Amended by Staff (6-24-93)
CITY PLANNING COMMISSION
1231 "I" STREET, SUITE 200, SACRAMENTO, CA 95814

- APPLICATION:**
- A. Negative Declaration
 - B. Mitigation Monitoring Plan (Staff withdrawn)
 - C. Rezone 1.34± vacant acres from Standard Single Family (R-1) to Single Family Alternative (R-1A).
 - D. Tentative Map to subdivide one parcel totaling 1.34± vacant acres into eight single family parcels in the Single Family Alternative (R-1A) zone.
 - E. Special Permit to construct eight single family residences in the Single Family Alternative (R-1A) zone.
 - F. Subdivision Modification to create one lot greater than 160 feet in depth.

LOCATION: 6712 Lemon Hill Avenue
(City Council District 6)

PROPOSAL: The applicant is requesting the necessary entitlements to subdivide 1.34± vacant acres into eight lots for single family development.

EXHIBIT - A3

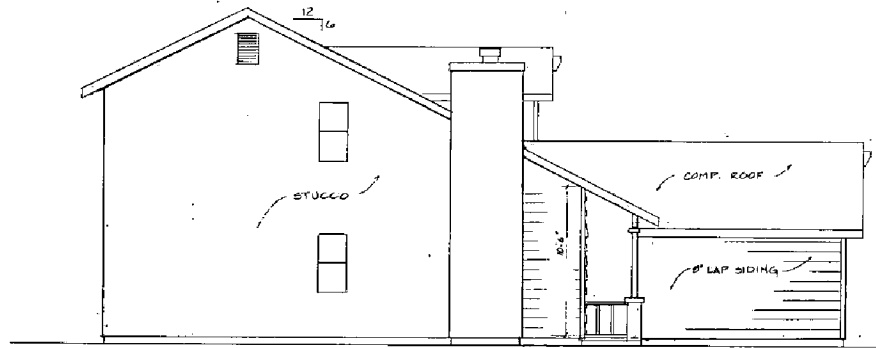
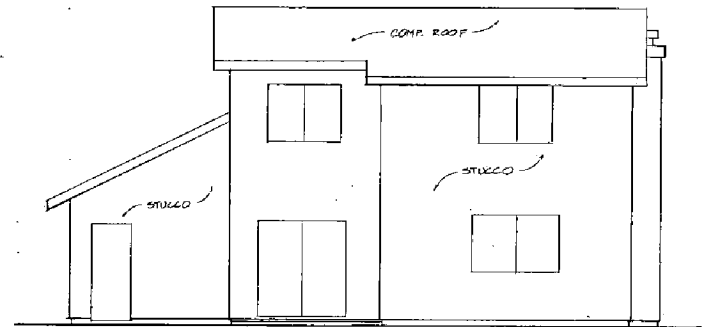
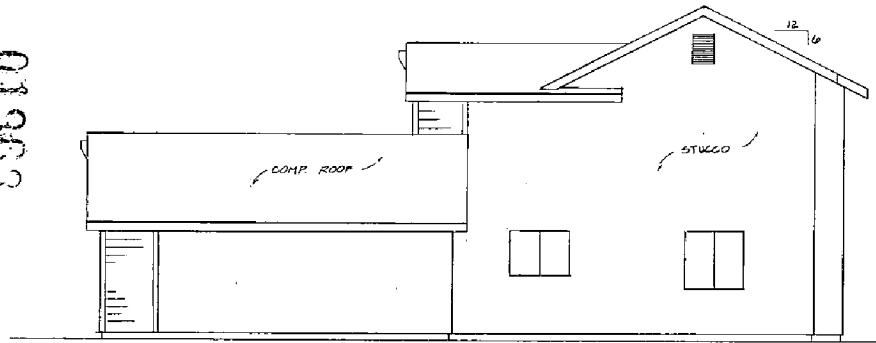
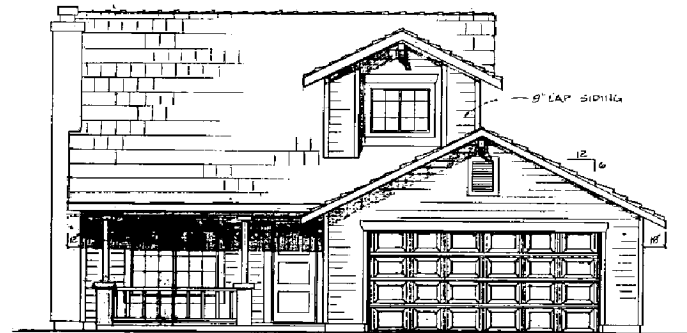
The proposed single family development will contain eight single family detached units. Each unit will be a 1,369 square foot two story with a 528 square foot two car garage. Each house will contain four bedrooms and two baths. The proposed exterior materials are stucco and horizontal wood siding. The rear elevation of the house presents the appearance of a two story stucco wall. Staff recommends a porch trellis that extends at least six feet out be constructed over the dining room door to provide a visual break from the stucco mass. Additionally, a two foot overhang trellis should extend along the rear elevation over the master bedroom window on the four units with a south facing rear elevation to provide visual relief and a sun screen. The units with a north elevation should carry a belt board along the rear elevation from the trellis area past the master bedroom window to the corner. The roofs will consist of dimensional composition shingles. Staff recommends the roofing be 25 year laminated dimensional shingles or the equal. The subdivision will be done in pastel colors. Staff recommends the applicant submit a formal application for the project to the Design Review Board Staff for review and approval. Staff recommends that the houses have no heating or air conditioning units installed on the roof tops; the garage doors should be metal sectional with raised panels; and the front yards shall be landscaped with lawn, shrubs, one or two trees, and an automatic irrigation system.

3. The applicant shall submit a formal application for the project with revised elevations to the Design Review Board Staff for review and approval to include :

- a. A porch trellis that extends at least six feet out and located over the dining room door;
 - b. A two foot overhang trellis shall extend along the rear elevation over the master bedroom window on the four units with a south facing rear elevation;

- c. The units with a north elevation shall carry a belt board along the rear elevation from the trellis area past the master bedroom window to the corner;

- d. The roofing shall be 25 year laminated dimensional shingles or the equal;
 - e. The houses shall have no heating or air conditioning units installed on the roof tops;

EXHIBIT - A7

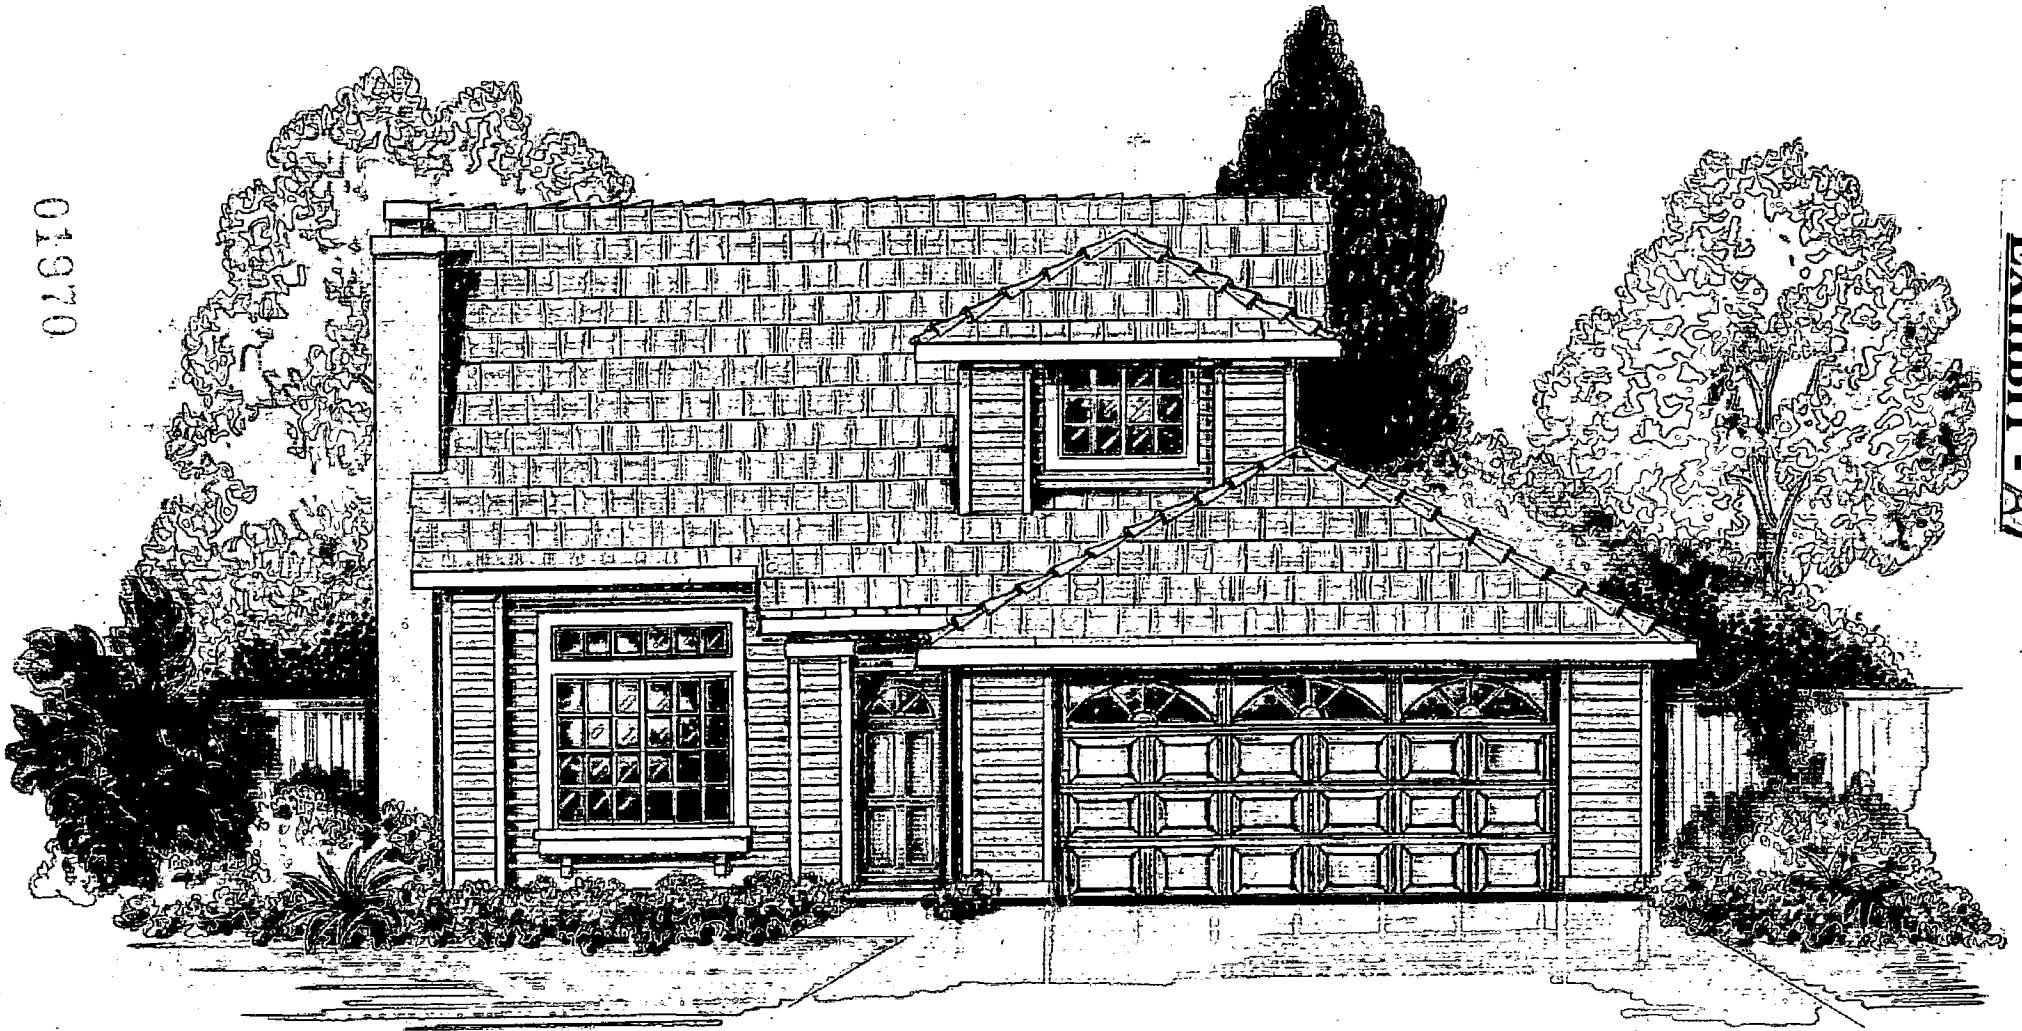
The submitted site plan indicates that Francine Drive will be extended to provide street frontage for the lots. A temporary turn-around for emergency vehicles and waste removal trucks will be located on Lots 3 and 4 until Francine Drive is further extended by new development to the west. Staff has no objection to the map provided the conditions listed in the attached resolution are met.

The site plan indicates the proposed eight single family units will have variable front yard setbacks. The front setbacks will range from 20 feet to 40 feet. Although the setbacks stagger, the location of the garages on the lot does not create a visual appearance that the garages are staggered. Staff recommends the applicant provide a staggering of the units on the lots to break the solid line of garage doors by reversing the house plan on Lot 7 and moving the house on Lot 4 further back.

The applicant is required by the Fire Department to provide a turn-around for emergency vehicles at the end of the extended Francine Drive. The proposed temporary turn-around will be located on Lots 3 and 4. The Fire Department requires this area be striped in red and marked "No Parking." The paving required for the turn-around and the driveways for each house on these two lots will cover approximately 71 percent of the front setback area. While this percentage exceeds the usual 40 percent paving maximum for the front setback area, the excess is necessary to meet various City Department requirements. The (R-1A) zoning allows for

1. Lot 4 shall not be developed as a Deep Lot.
2. The applicant shall reverse the house plan on Lot 7, move the house on Lot 4 further back, and submit a revised site plan for Planning staff review prior to the issuance of building permits.

- f. The garage doors shall be metal sectional with raised panels; and**
 - g. The front yards shall be landscaped with lawn, shrubs, one or two trees, and an automatic irrigation system.**
- 4. The proposed temporary turn-around shall be striped in red and marked "No Parking."**
